ATTACHMENT F

Re: Revision to **STORMWATER MANAGEMENT CONCEPT PLAN and SITE DEVELOPMENT STORMWATER MANAGEMENT PLAN**
Strathmore Square
Address: Grosvenor – Strathmore Metro, North Bethesda, MD
PP Amendment #: 120190180B
SP#: 820220070 for Lot 3 and Parcel B
SM File #: 283907 – Revision 2
Tract Size 14.58 ac/ 635,073 sq ft
Total Concept Area: 14.58 ac/ 635,073 sq ft
Legal Description: Tax Map HP123 - #04-00055028 to be subdivided into 7 lots and one parcel (to be developed as a park)
Zoning: CR 3.0, C.5, R-2.75, H-300
Watershed: Rock Creek/I
Type of Development: Redevelopment

820220070 Strathmore Square

**Department of Permitting Services
Fire Department Access and Water Supply Comments**

Fire Department Access Review

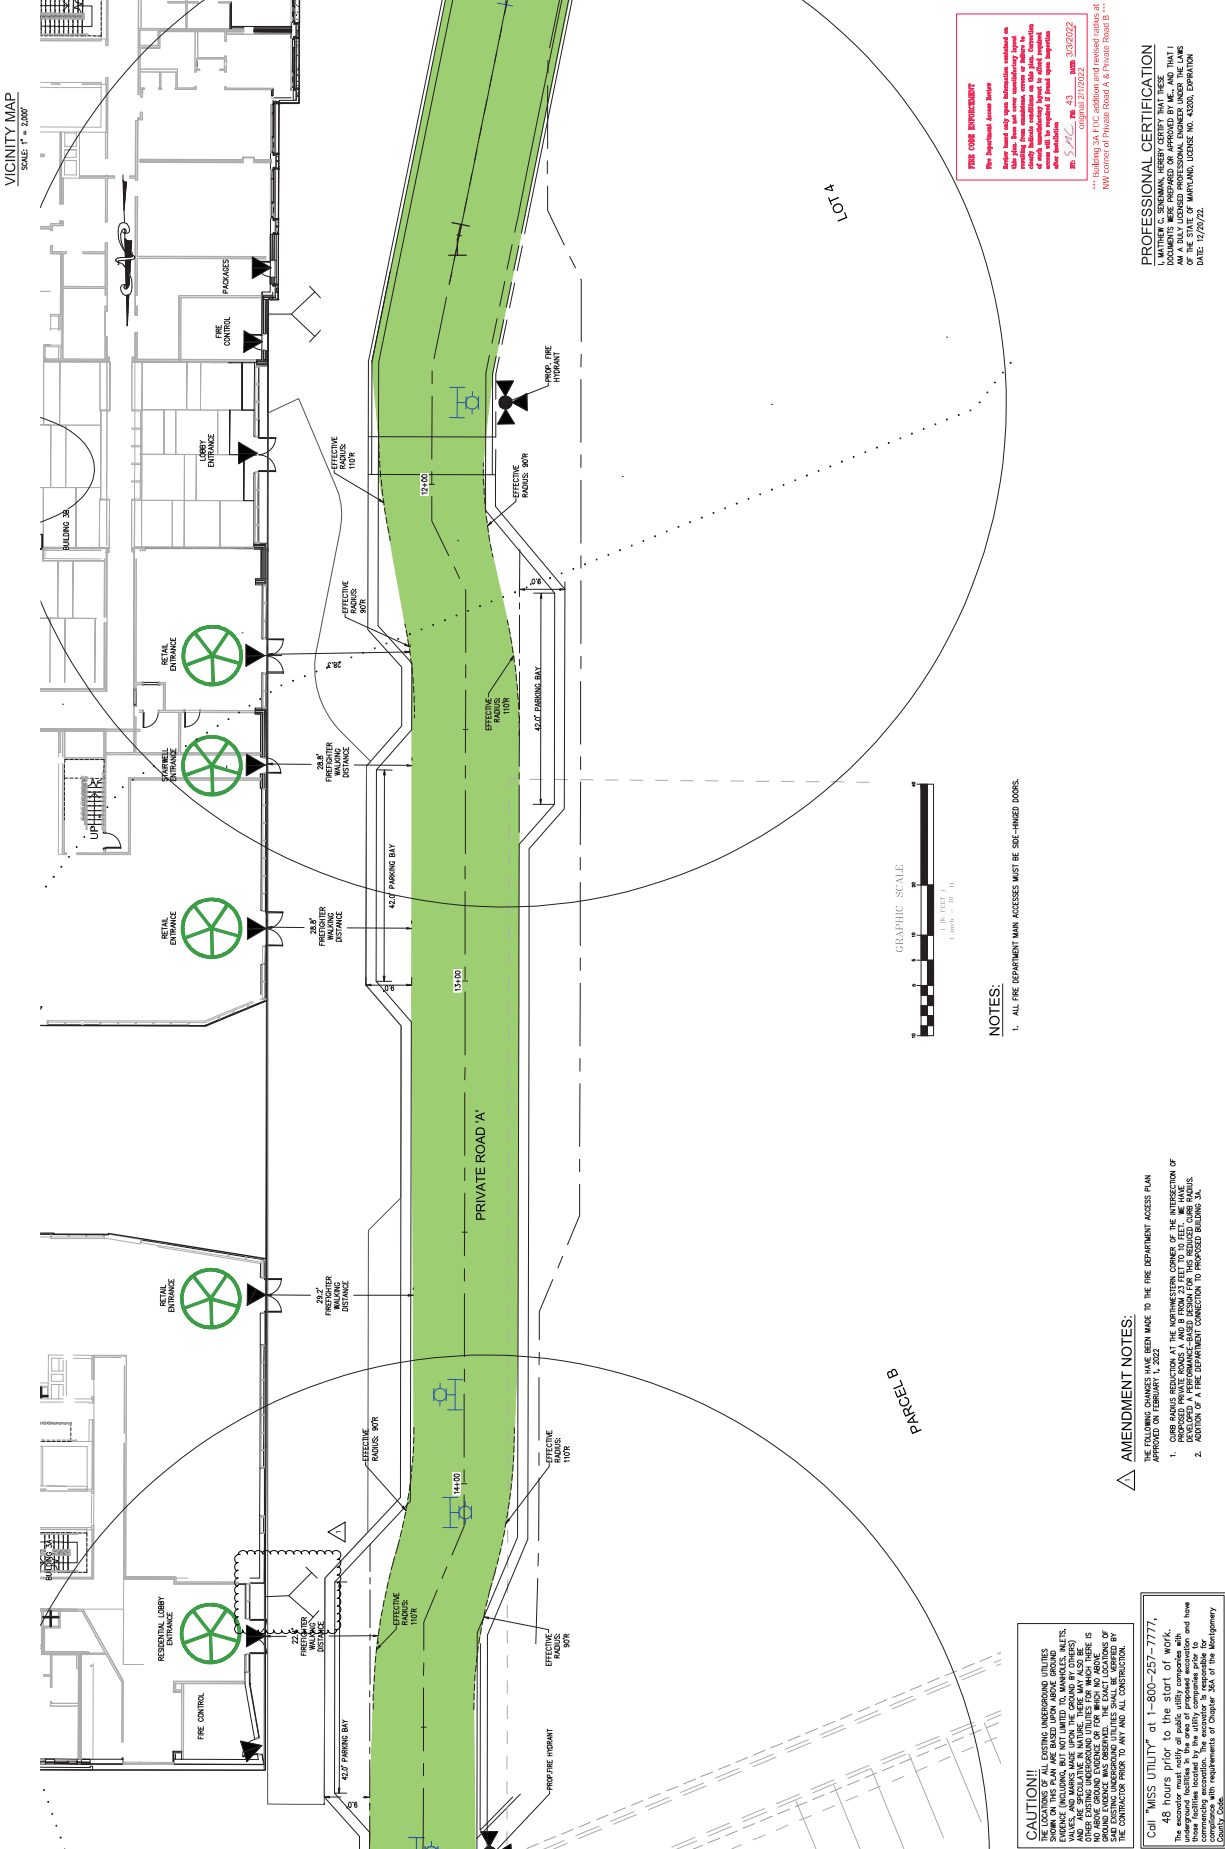
***** 3/3/2022 Amendment: Building 3A FDC addition and revised radius at NW corner of Private Road A & Private Road B *****

***** Building 3A FDC addition and revised radius at NW corner of Private Road A & Private Road B *****

This letter is written to request the following: 1) a performance-based design for select elements of the fire access for the Strathmore Square Phase 1 Site Plan that do not meet the requirements of MCER 8-16 Section 18.2.3.4.3.1.1 as outlined below; 2) to document the addition of an FDC to Building 3A to previously approved plan.

The project proposes a new north-south private road 'A' connecting the existing WMATA bus and Park and Ride exit drive at the south end of the site to the existing WMATA parking garage driveway to the north. As part of this new Road A connection, WMATA Park and Ride vehicles, as well as emergency vehicles, will be provided the opportunity to turn left at this new intersection with Road A and travel north bound. Given that the existing WMATA bus and Park and Ride exit drive is two lanes wide and with only eastbound, we propose to reduce the northwestern curb return radius to 10' in order to minimize pedestrian crossing distances and maintain a more compact intersection design. We have ensured to maintain all required fire truck turning movements, namely the eastbound to northbound movement. The attached plan uses Auto-Turn to illustrate that a fire truck can make this left turn maneuver with the northwest curb return reduced to a 10' radius.

- AMENDMENT NOTES:**
- THE FOLLOWING CHANGES HAVE BEEN MADE TO THE FIRE DEPARTMENT ACCESS PLAN APPROVED ON FEBRUARY 7, 2022. THE AMENDMENT CHANGES OF THE AMENDMENT OF PROPOSED PRIVATE ROADS A AND B FROM 21 FEET TO 15 FEET. WE HAVE
- AMENDMENT OF THE DEPARTMENT CONNECTION TO PROPOSED BUILDING 3A.
 - AMENDMENT OF THE DEPARTMENT CONNECTION TO PROPOSED BUILDING 3B.
